SITE INSPECTION MEMO

Re: Follow-Up Inspection – Blackstone Logistics Center – Lackey Dam Road & Route 146, Douglas, Sutton & Uxbridge, MA (DEP File Nos. 303-0947, 312-1114, & 143-1017)

1. Recently re-graded Infiltration Basin #2

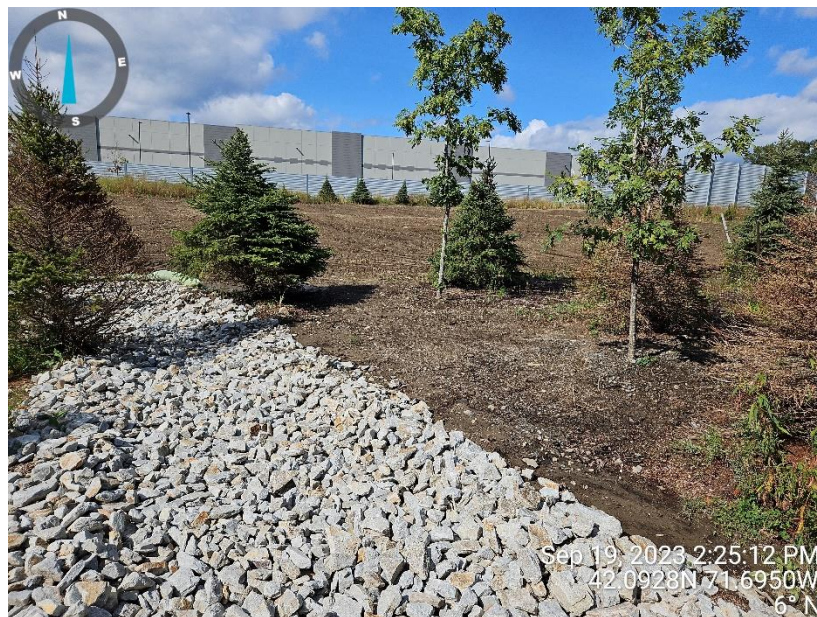
Upon entering the site I noted that a street sweeper was working to clean paved surfaces. I also noted that Infiltration Basin #2 had recently been re-graded and had been accessed from the site driveway. Re-graded surfaces within the basin were largely unstabilized, except for new blankets on the northerly slope. I also noted that a large area, across the site driveway from Basin #2, had recently been re-graded and was unstabilized. Photos of these areas are attached. **All disturbed surfaces should be stabilized immediately and confirmation of same should be provided. Going forward, please notify the Towns when this sort of work is going to commence and provide SWPPP reports, as required.**
